City of Portland Historic Landmarks Commission

Design Advice Request #2

SUMMARY MEMO

Re: EA 22-184037 DA – Jefferson High School Development
Design Advice Request #2 Commission Summary Memo – May 22, 2023

1909 North Elevation

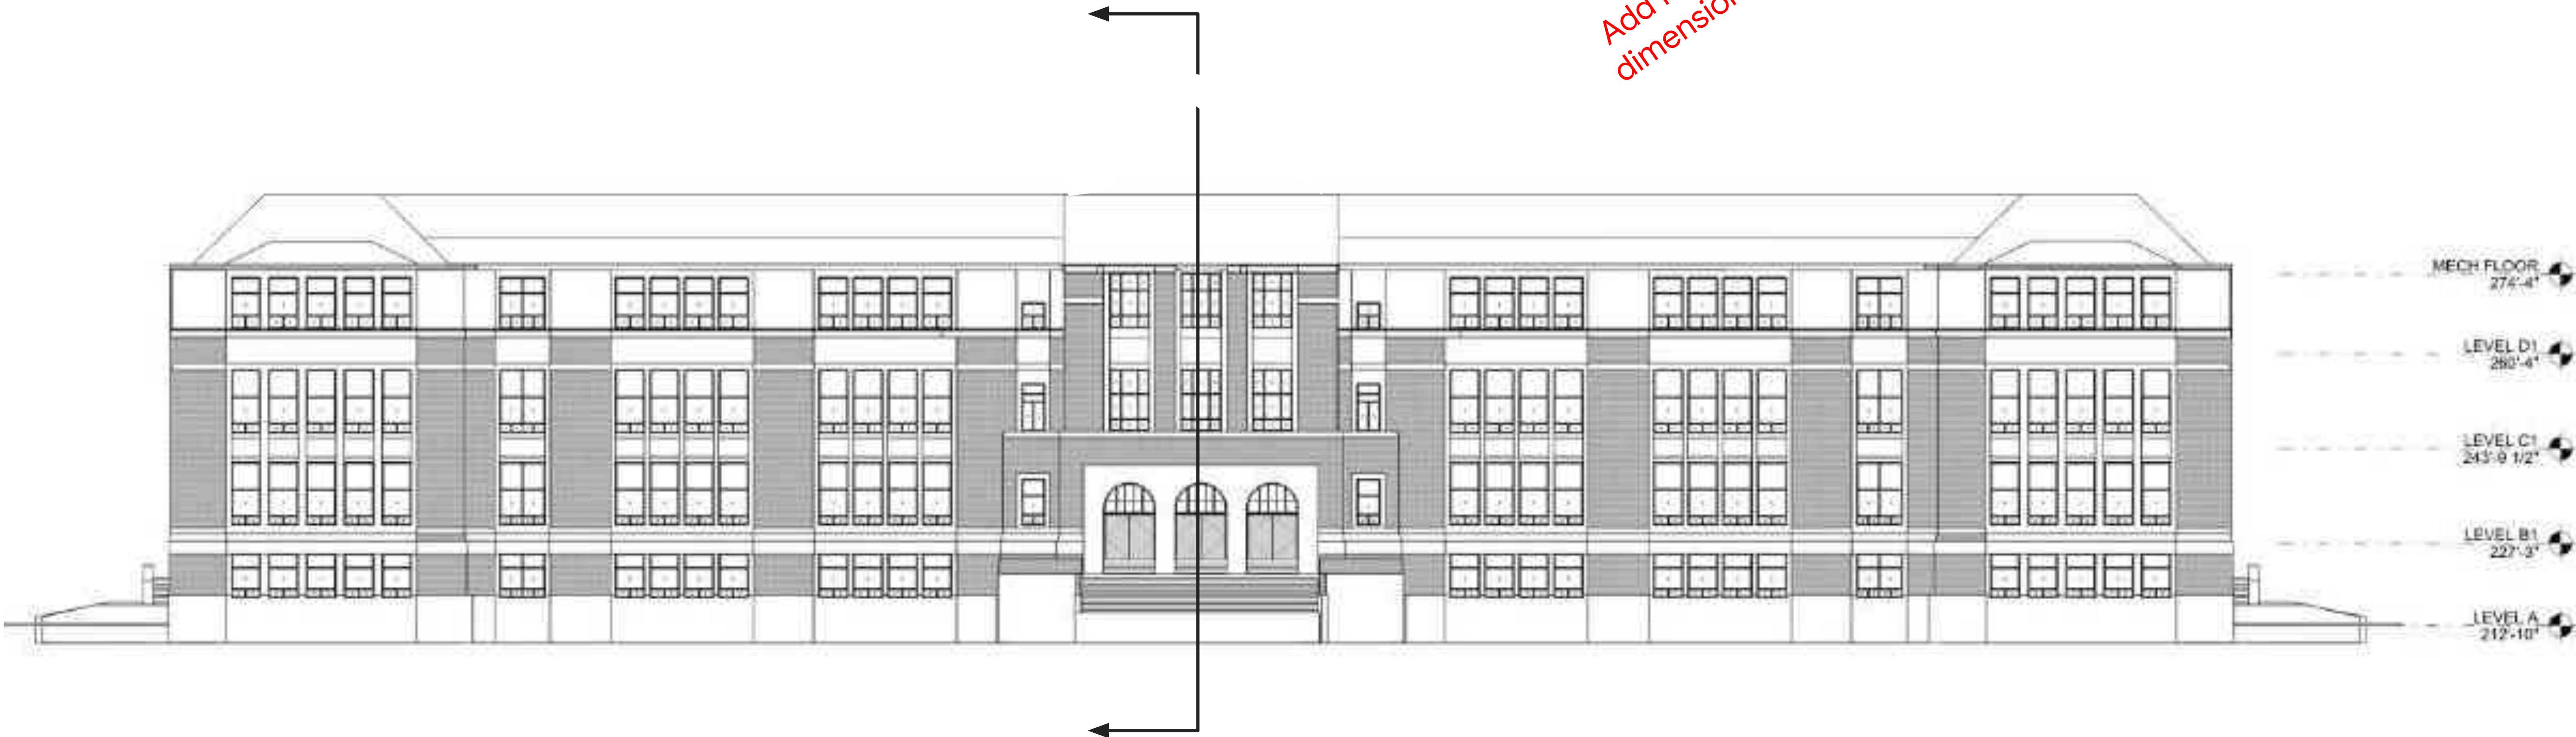
Clarify approach
for spandrel area

Proposed North Elevation

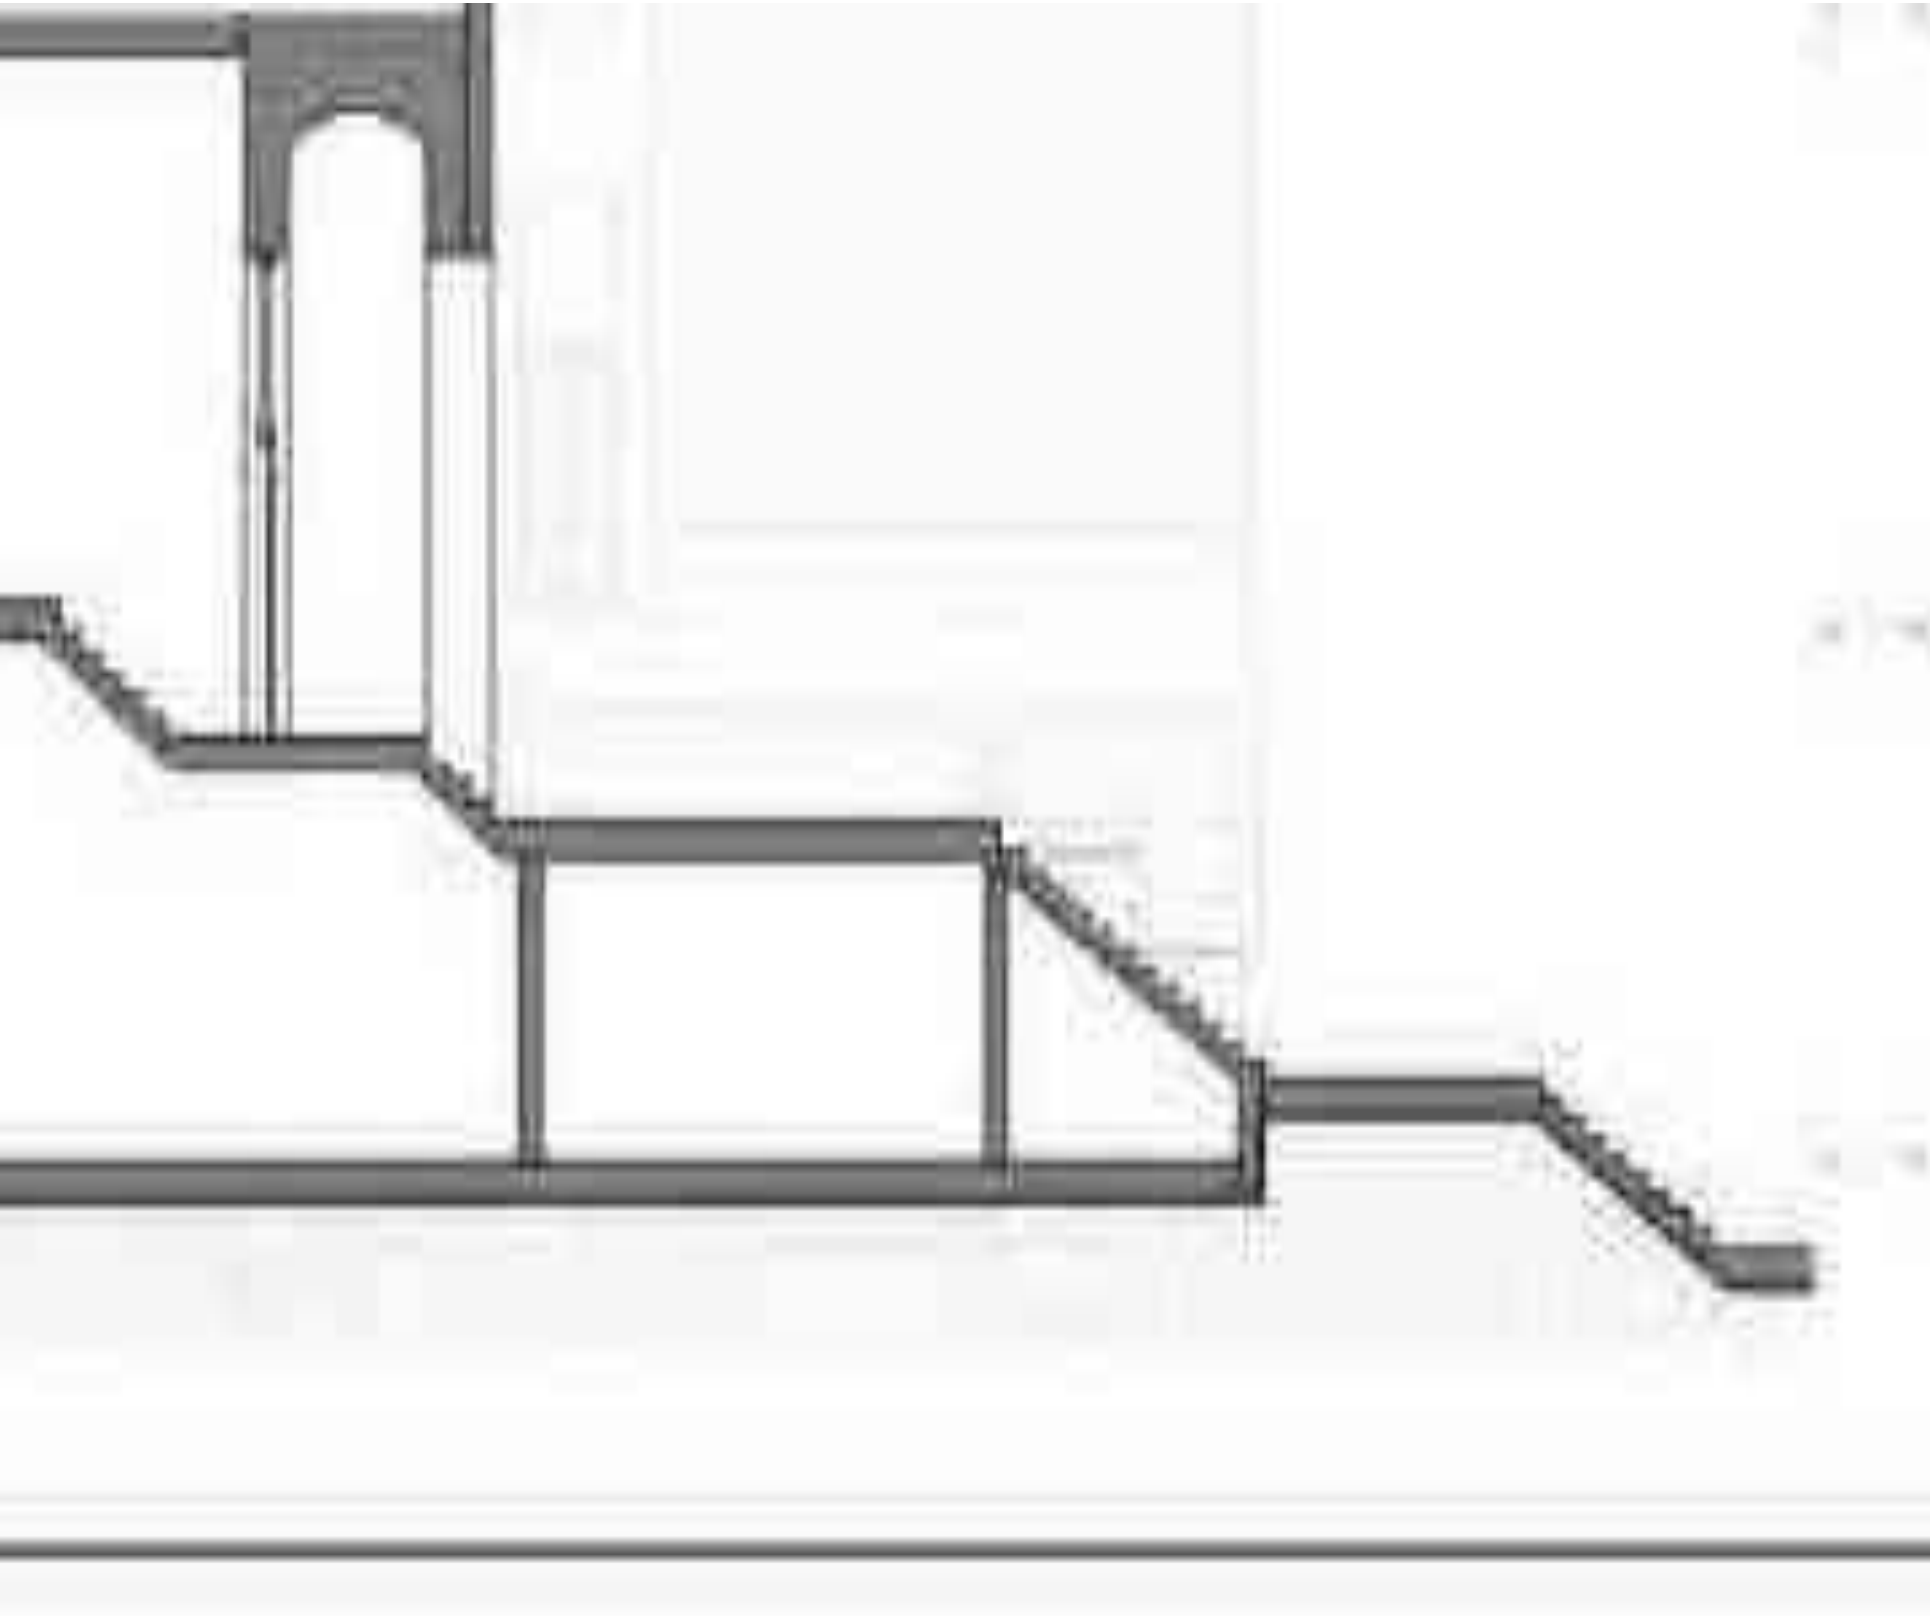
Add floor elevations,
dimensions and notes
